## QUALITY ASSURANCE -- NON-CONFORMANCE REPORT

**Report No:** NCR-000260

**Reference Description:** West Shaft, Lift 3, Skin C; Missed MT indication

**Job Name:** SAS Superstructure

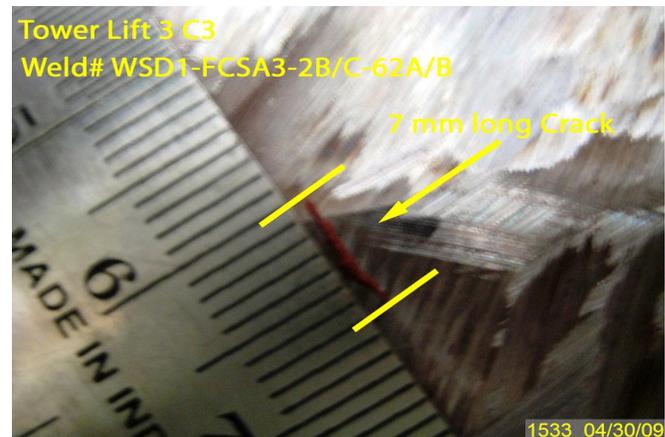
QA discovered a 7mm long linear indication in weld WSD1-FCSA3-2B/C-62A/B that had been previously inspected and accepted by ZPMC QC. The indication is located in West Shaft, Lift 3, Skin C.

Special Provisions Section 8.3 – “Quality Control (QC) shall be the responsibility of the Contractor. As a minimum, the Contractor shall perform inspection and testing of each weld joint prior to welding, during welding, and after welding as specified in this section and to ensure that materials and workmanship conform to the requirements of the contract documents.”

AWS D1.5-2002 Section 6.26.2 – “Welds that are subject to MT in addition to visual inspection shall have no cracks”

WSD1-FCSA3-2B/C-62A(62B)

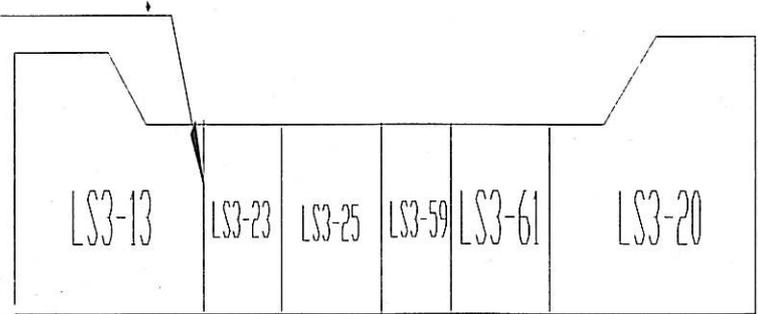
探伤位置图  
 Scheme showing the test part

Reference Description: West Shaft, Lift 3, Skin C; Missed MT indication

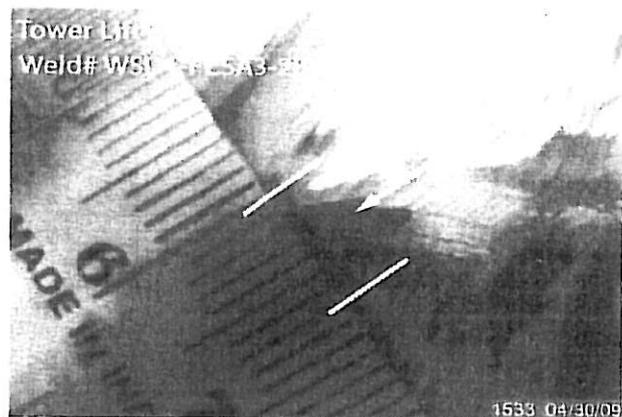
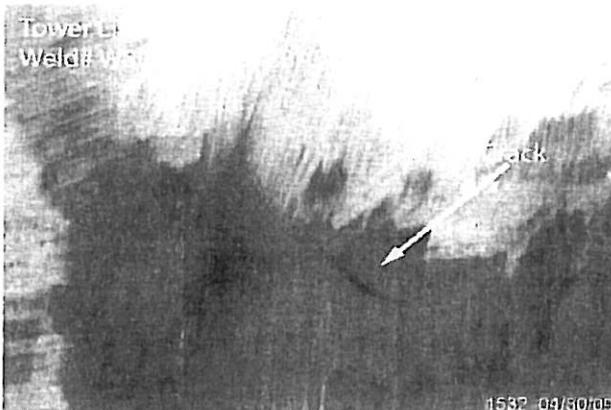
QA discovered a 7mm long linear indication in weld WSD1-FCSA3-2B/C-62A/B that had been previously inspected and accepted by ZPMC QC. The indication is located in West Shaft, Lift 3, Skin C.

Special Provisions Section 8.3 – "Quality Control (QC) shall be the responsibility of the Contractor. As a minimum, the Contractor shall perform inspection and testing of each weld joint prior to welding, during welding, and after welding as specified in this section and to ensure that materials and workmanship conform to the requirements of the contract documents."

AWS D1.5-2002 Section 6.26.2 – "Welds that are subject to MT in addition to visual inspection shall have no cracks"
